Quiet Use Coalition comments regarding the Transmission Line Rebuild project

Please accept and consider the following comments regarding the draft EA (DEA) for the proposed Public Service Company of Colorado (Xcel Energy) 9254/9257 and 9255 Transmission Line Rebuild project on behalf of the Quiet Use Coalition.

CPW Ptarmigan winter habitat and overall range as blue shading.

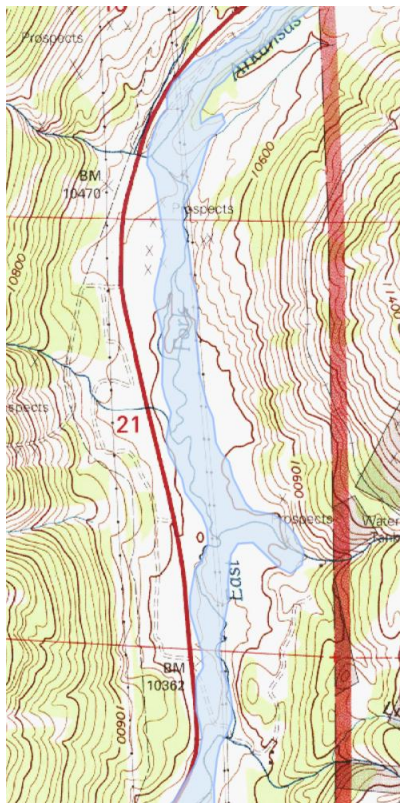
Colorado Parks and Wildlife Species activity mapping GIS data indicates that there is an area of BLM land east of Highway 91 where this power line passes through approximately 1.53 miles of ptarmigan overall range and winter habitat. See image below.

CPW specifies a best management practice for White tailed ptarmigan winter habitat and overall range to seasonally close trails within those habitats to all use May 1- July 15.⁹

Project activity should not occur within this ptarmigan habitat during that time. Future project related human visitation for monitoring or other reasons should be avoided in those habitats during that time period.
